August 28, 2001
JB 18457-I

Addendum Geologic and Soils Engineering Exploration Report #3
Proposed Landslide Repair and Multi-Unit Condominium and Town Home Buildings
Tentative Tract 52928, Lot 1 (Condominiums)
17331-17333 Tramonto Drive
Pacific Palisades, California

Grading Section Log # 31587-01

TABLE 6
SUMMARY OF STRENGTH TEST RESULTS OF PRINCIPAL SUBSOIL STRATA

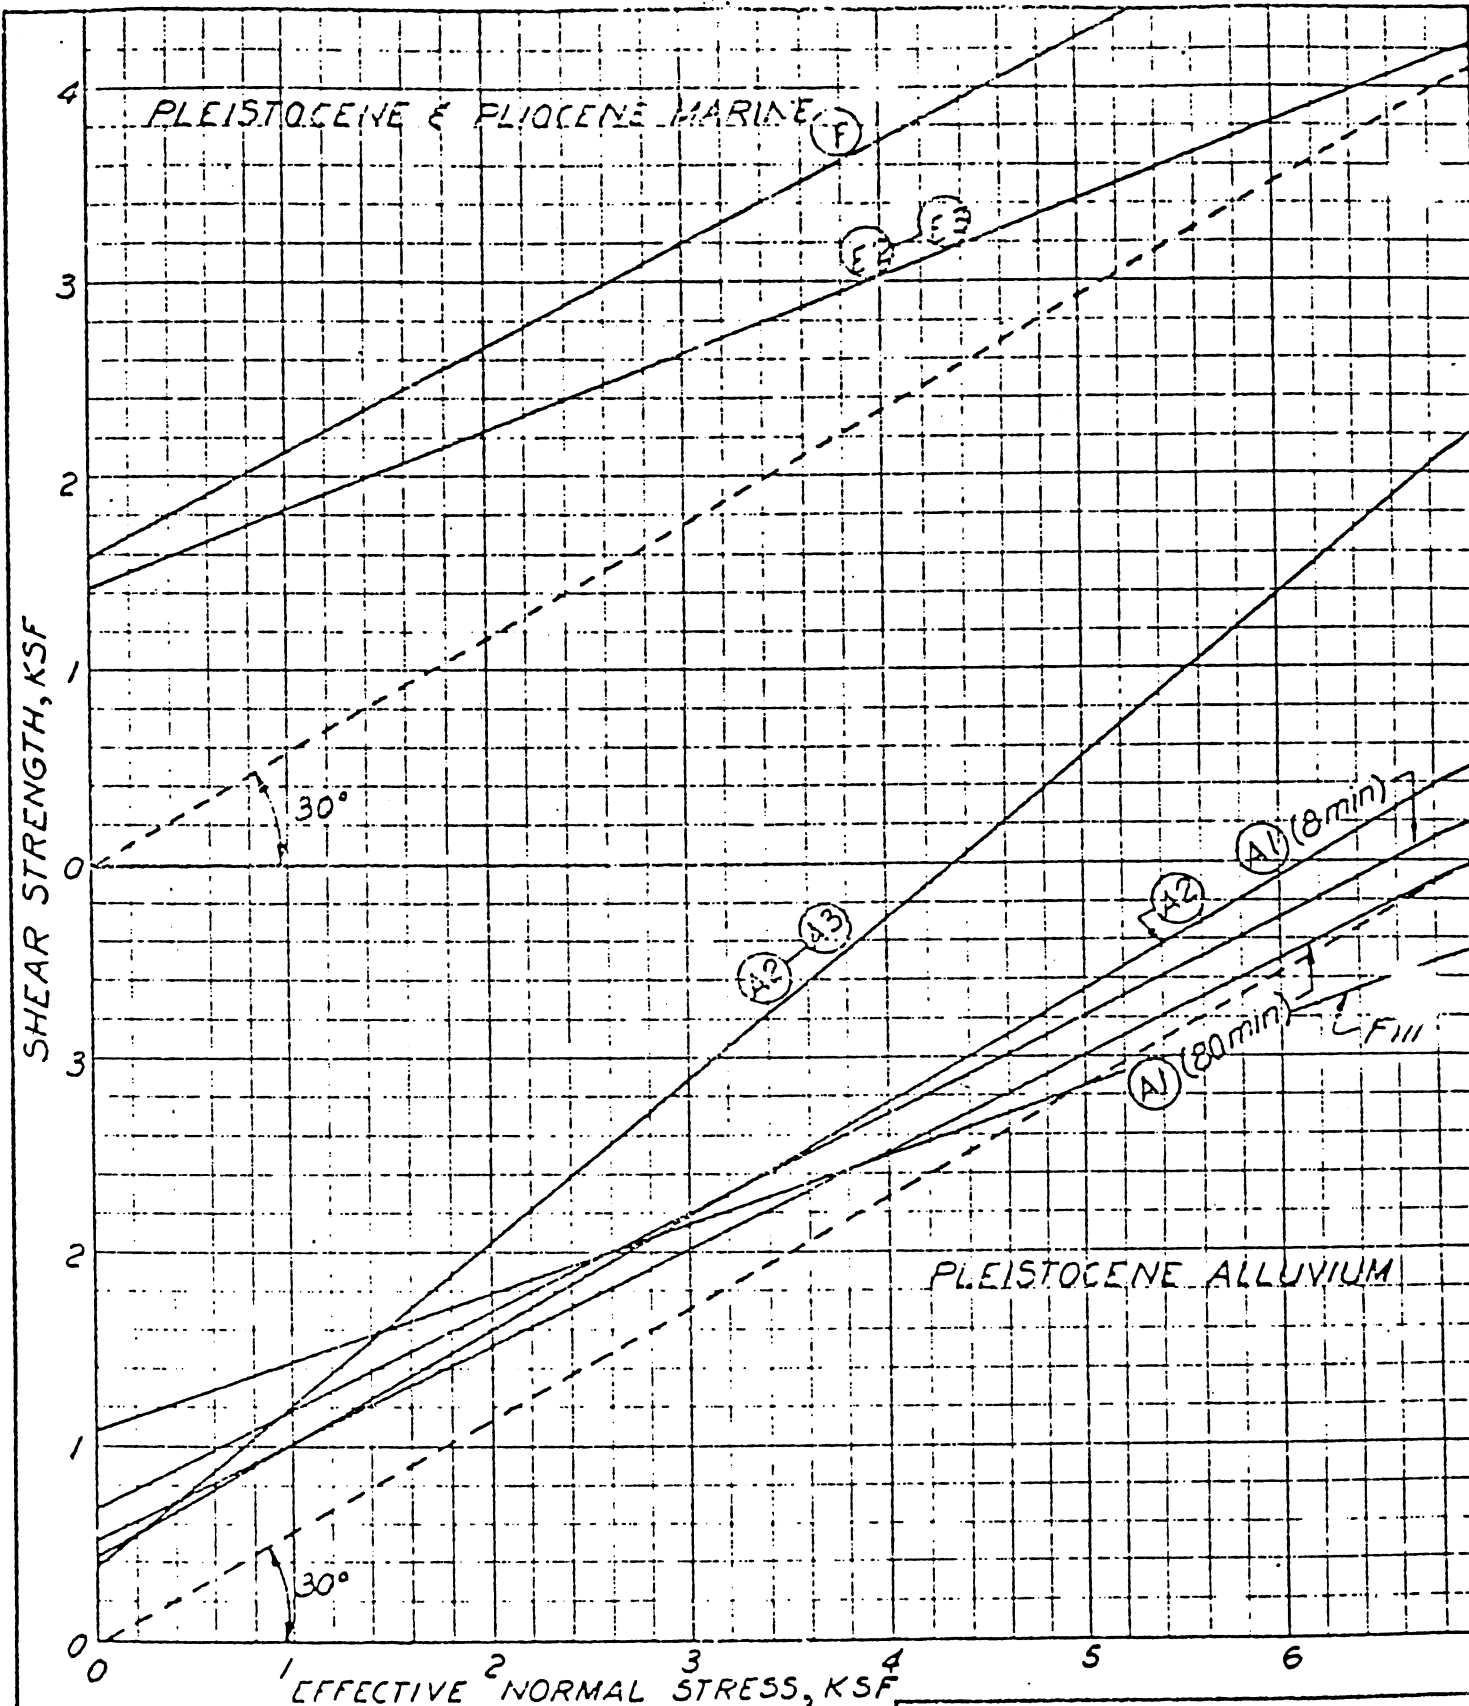
Item - 6 *Provide a statement of responsibility indicating that shear strength obtained from Moran et al. report were reviewed and concurred with. Also provide shear strength diagram for the basalt and terrace stratum and conditions of the tests.*

A study of the Pacific Palisades by Moran, Proctor, Muesser & Rutledge, 1959 (*Final Report, Pacific Palisades Landslide Study*) contains shear test results of nearby terrace. Table 6 - Summary of Strength Test Results of Principal Subsoil Strata and Plate No. 10 - Strength Summary of Pleistocene-Pliocene Materials are enclosed.

The J. Byer Group, has reviewed the reports and published findings by GeoSoils and Moran, Proctor, Muesser & Rutledge and concurs with their findings. The J. Byer Group, accepts geotechnical responsibility for utilizing the GeoSoils shear strength of the basalt and the Moran, et al., strength of the terrace.

SECTION Q-Q

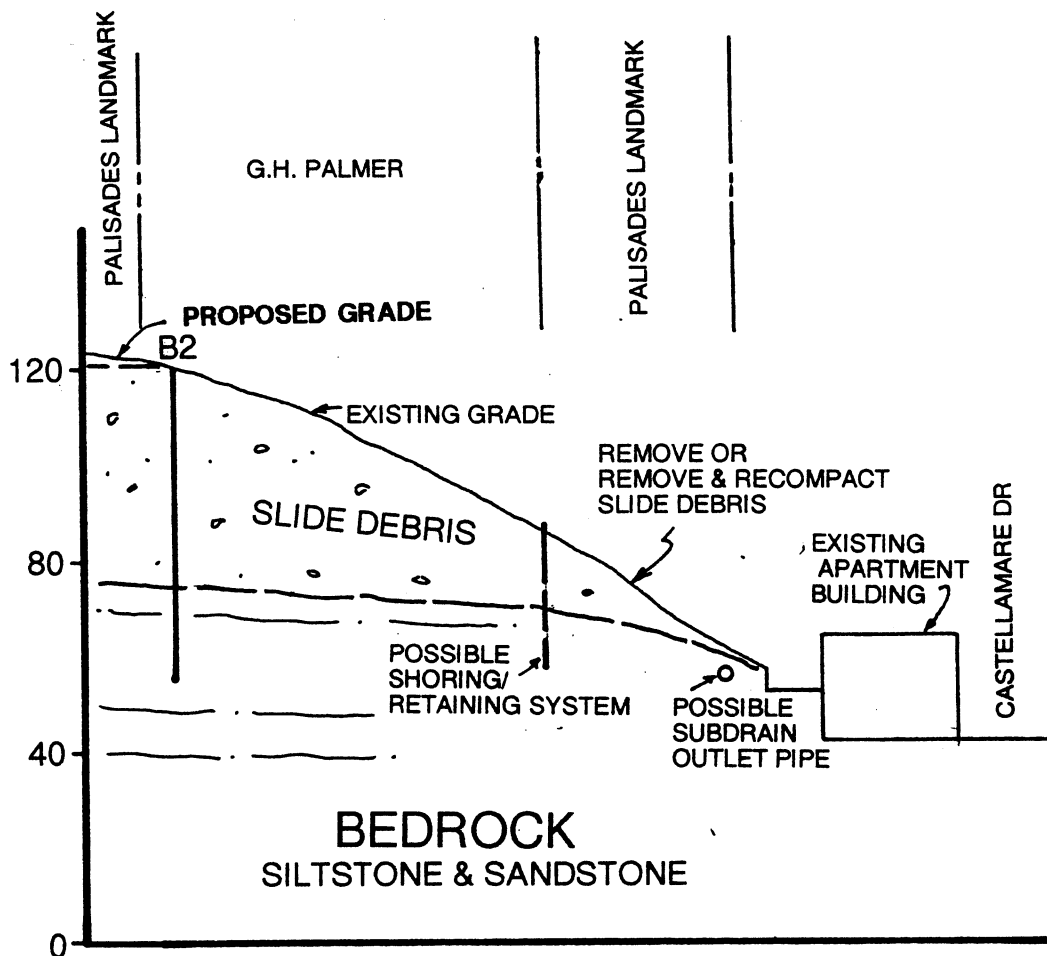
Item - 4 *Show the proposed grade on sections A, B, C, G, E-H, K, L and Q-Q.*

Formal grading and development plans have not been developed yet. However, it is planned to balance the earthwork within the site. Thus, the finish grades will not be much different than the existing. The proposed grades are shown on Sections A, B, C, G, E-H, K, L and Q-Q.

SECTION K

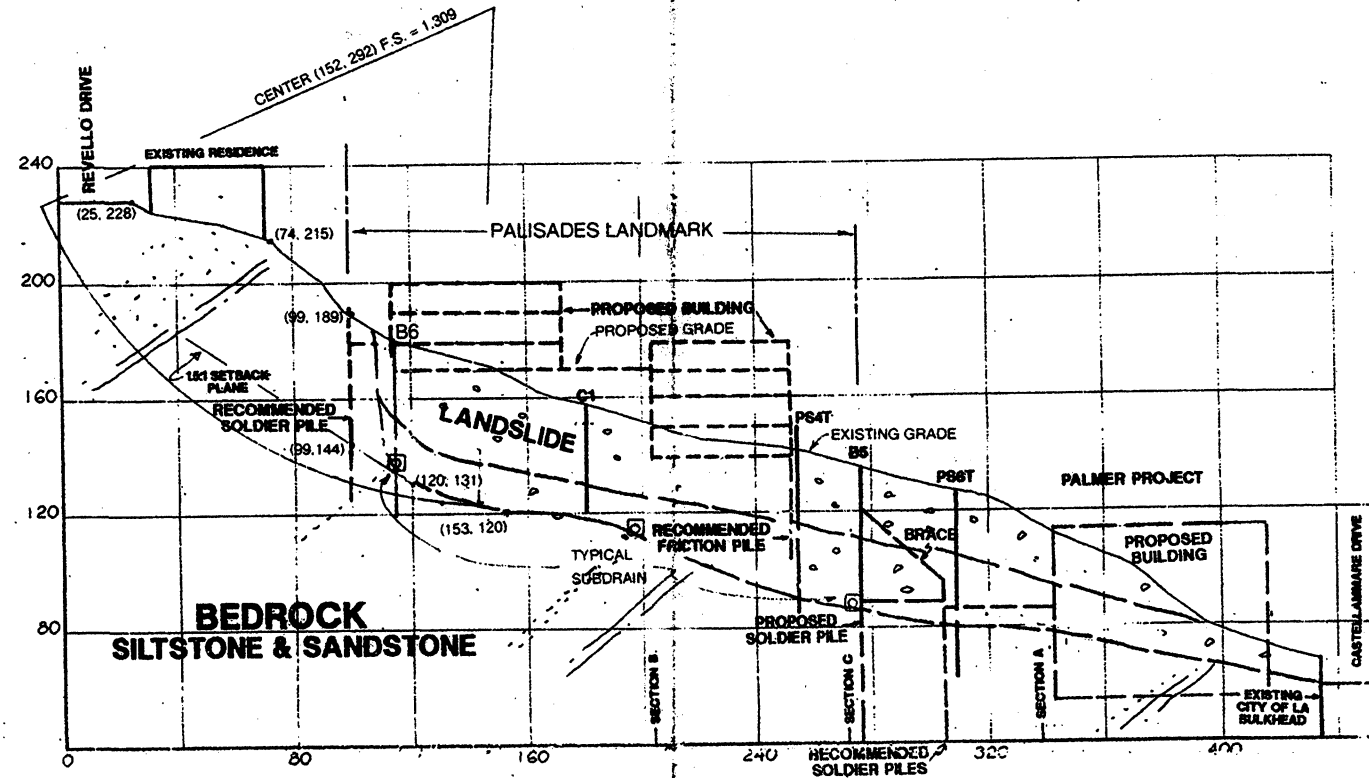
Item - 1 *Revise recommendations for piles P31 through P40; section "K" now indicates that a calculation for support of up to 45 feet of bedrock is required adjacent to the landslide. In addition, the recommended embedment of the piles below 1½:1 is not acceptable. Temporary piles shall be embedded below a plane with safety factor of 1.25, revise recommendations.*

Calculations within our June 26, 2001 report indicate that the proposed system of temporary piles and 1½:1 setback plane have a safety factor of greater than 1.25. Section K, which is the most critical with respect to the temporary slopes, has a temporary safety factor of 1.309. A 1.25 failure plane would be steeper than the 1½:1 plane and less conservative. It is the opinion of The J. Byer Group that the soldier piles should be embedded below a 1½:1 plane projected up from the base of the slide.

SECTION H-H

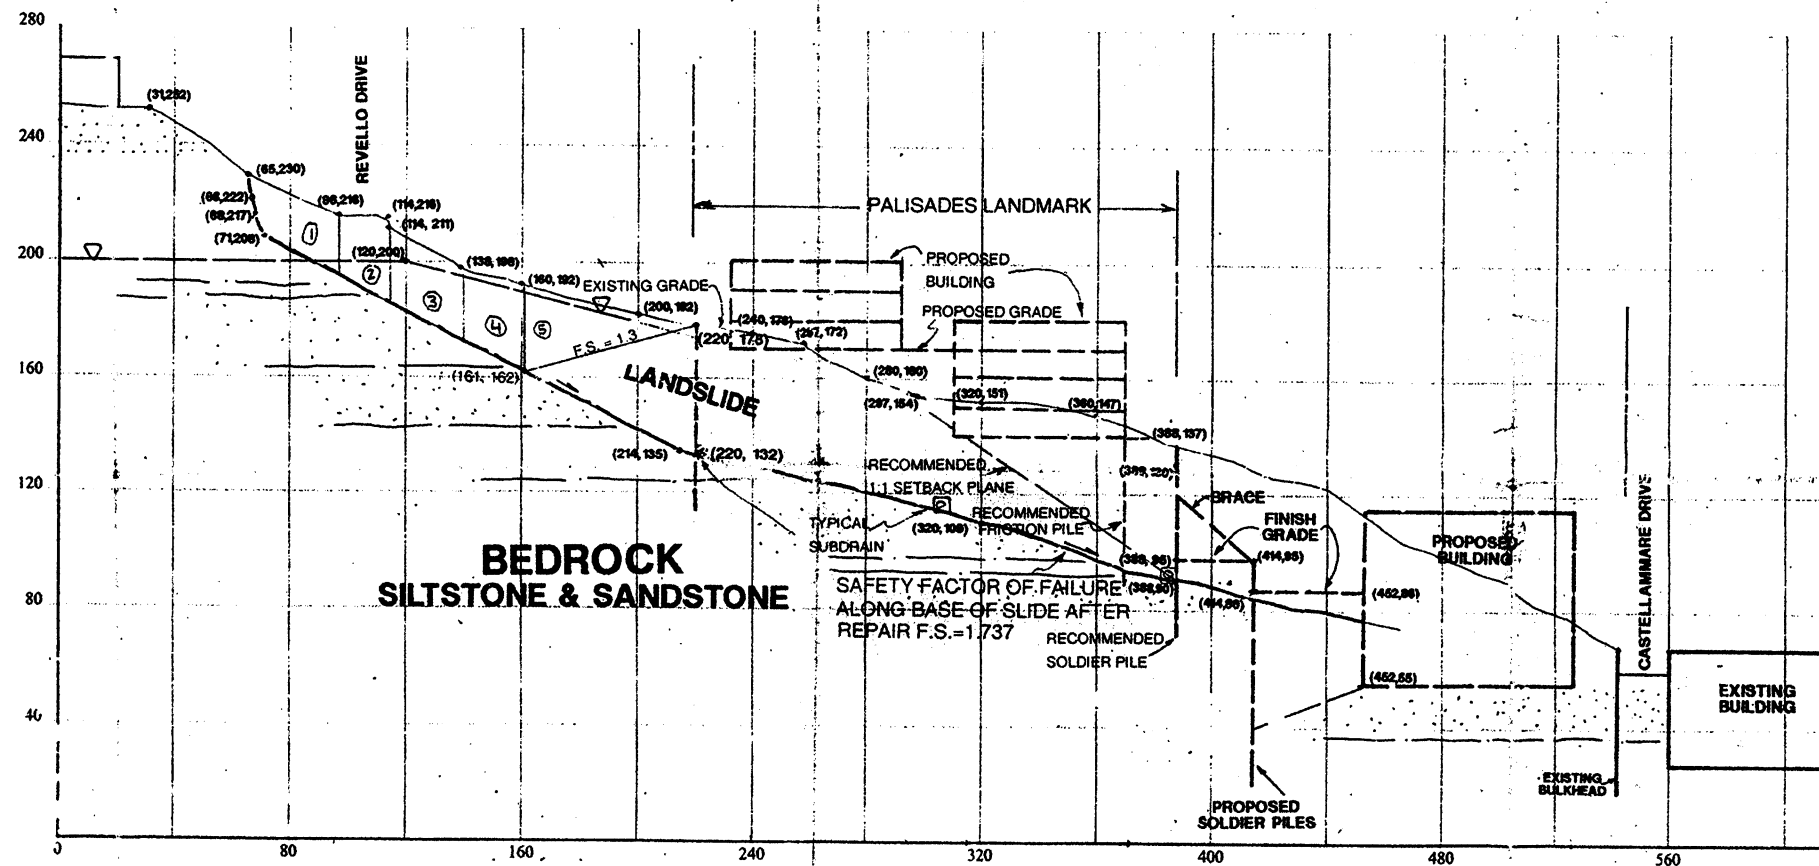
Item - 2 *Revise analyses for overtopping of the landslide over the proposed retaining wall to include groundwater.*

Item - 3 *Revise slope stability calculations for the proposed repair (Section H-H). The computer input indicates that locations of the external forces 1 & 2 are assigned away from the true locations of soldier pile walls. Explain the assumed magnitude of EFP=30 PCF for the uphill piles and EFP=65 PCF for the downhill piles. Also, correct the "Y" boundary coordinates for the upper soldier pile wall, they are in the reverse order.*

The safety factor of a potential failure surface that overtops the soldier piles and the proposed repair was analyzed based upon Section H. For a conservative analysis, it was assumed that the subdrain system fails and the repair acts as a dam. Under such conservative assumptions, the safety factor is greater than 1.3. The low safety factor is not considered reasonable because there is no evidence that groundwater has ever been within 10 feet of the ground surface and a draw down in the groundwater surface adjacent to the subdrain system was ignored. It is not possible to grade or de-water offsite and the calculated safety factor is considered sufficient for the proposed project.

The resultant horizontal forces assumed for the soldier piles were modeled as anchors. The y-coordinates are assigned to $\frac{1}{3}$ the retained height. For the upper and lower rows, $\frac{1}{3}$ the retained height is 147.33 and 105.67 feet, respectively. Section H was revised to show the correct x and y coordinates at the top and bottom of piles for the anchor method. The x-coordinate need only be located upslope (lower x value) than the intersection of the slide plane, the bedrock, and the elevation of the y-coordinate. The exact location of the x-coordinate is not important as the magnitude of the anchor force is not a function of the embedment distance. The force is applied at the intersection of the failure plane and the y-coordinate. The anchor force methodology is contained within the REAME User's Manual (pages 58-60), which has been provided to the reviewing engineer.

The design fluid pressure on the lower row of soldier piles (equivalent fluid pressure = 65 pcf) is based upon Calculation Sheet #38 within our August 16, 2000 report. The calculation assumes that the piles support future compacted fill. As discussed on page 7 of our November 29, 2000 report, the upper row of soldier piles will have two loading conditions. During removal and recompaction of the slide debris, piles 1 through 30 will support slide debris. The design load on piles 1 through 30 will range between 145 and 175 kips per foot as determined in the previous reports. Recommended piles 31 through 40 will support bedrock above a 1½:1 plane projected up from the base of the slide. The recommended design fluid pressure on piles P31 through P40 is 65 pounds per cubic foot. The second loading condition occurs after the slide debris has been removed and replaced with compacted fill. Piles 1 through 30 should be designed for an equivalent fluid pressure of 30 pcf. Piles 31 through 40 are not needed for permanent stability. Tie backs or rakers may be utilized to assist the piles in resisting the higher temporary pressures.
